Re: NOAA's National Marine Fisheries Service's Comments on the November 30, 2022  
Draft License Application for the Skagit River Hydroelectric Project, Docket P-553-235

#### **NMFS' COMMENTS ON THE DLA**

**Figure 1.** Long term trends in Chinook salmon abundance, relative to recovery goals under consistently low productivity (yellow line) and High productivity (black line).

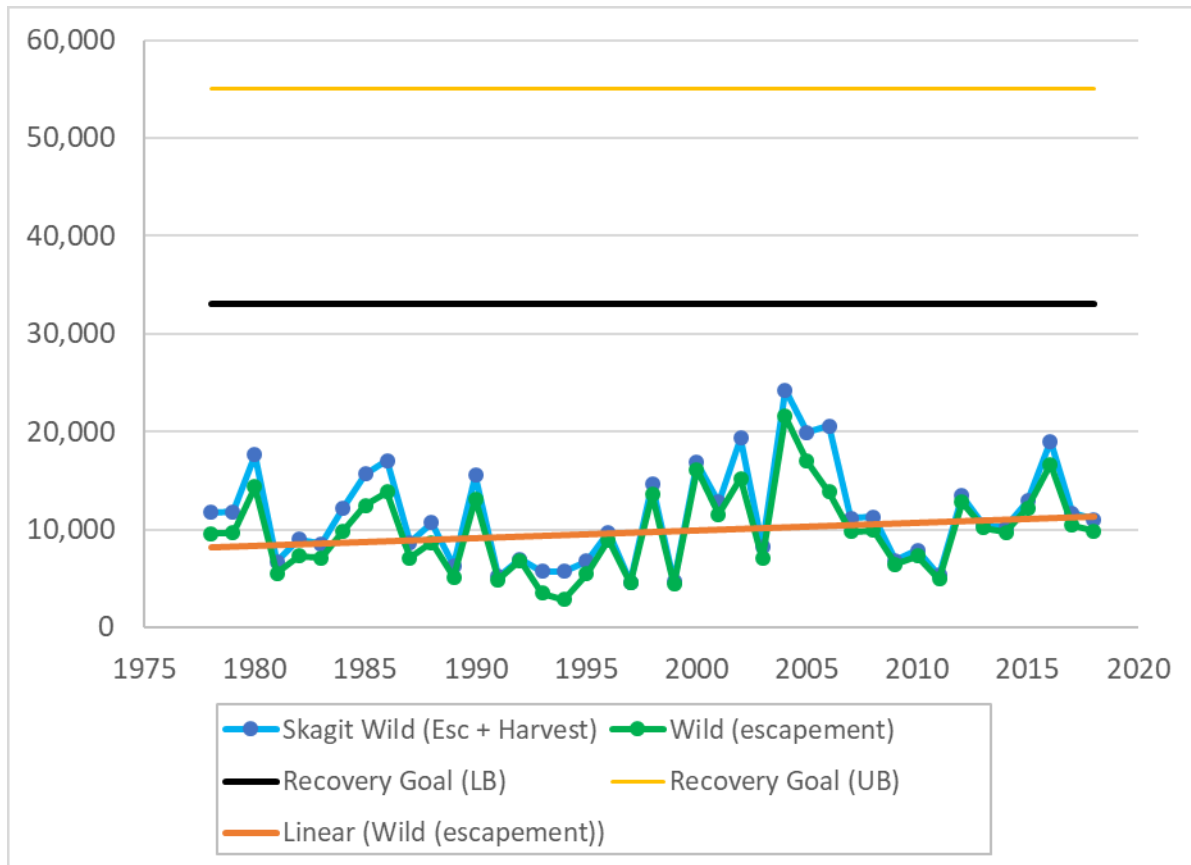
Ford (2022) describes the status and viability of ESA-listed Puget Sound Chinook salmon and steelhead populations. The DLA states that the Skagit Chinook salmon runs are the largest in the ESU (DLA Ex. E at 4-278). While this statement is accurate, we note that the Skagit River is the largest river draining into Puget Sound, and associated abundances of Chinook salmon *should be* the largest in Puget Sound. Therefore, this fact does not demonstrate that the Skagit populations are healthy or are unaffected by the Project. The DLA inappropriately alludes to dam operations as responsible for producing abundant populations (DLA Ex. E at § 4.2.3.2). Skagit River Chinook populations are at 10-20% of their recovery thresholds, and have sustained this static and depressed level of recovery for more than 30 years (Figure 1), throughout the duration of the current license. Further, the DLA mischaracterizes Ford (2022) by stating that all Puget Sound populations of Chinook salmon are below recovery thresholds, except Skagit River system populations. In fact, all Puget Sound Chinook salmon populations are below recovery thresholds (Figure 1; Ford 2022), and the FLA should correct this mischaracterization.
